BRANCHESTER LAKES · SUBDIVISION

SANITARY SEWER LIFT STATION

SHEET NO. 4 of 4

PUMP STATION LAYOUT

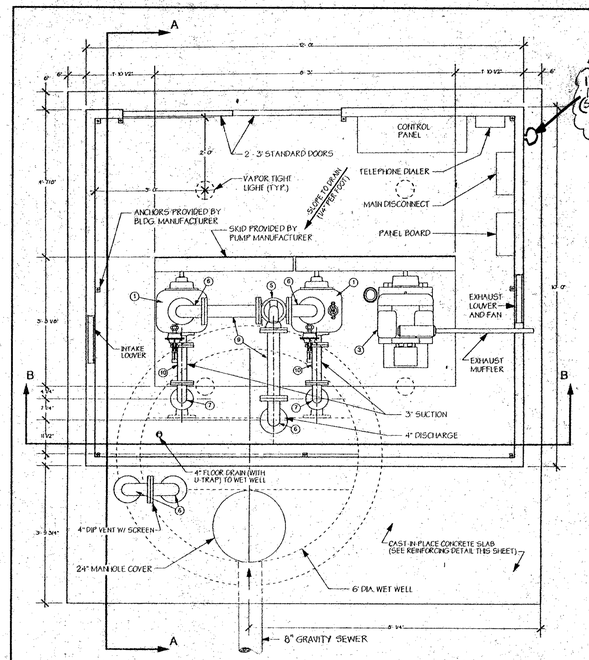
115 volt Alarm Horn & 115 volt Alarm Light Fixture (See spec motor Branch Components 0, 3 and 4)
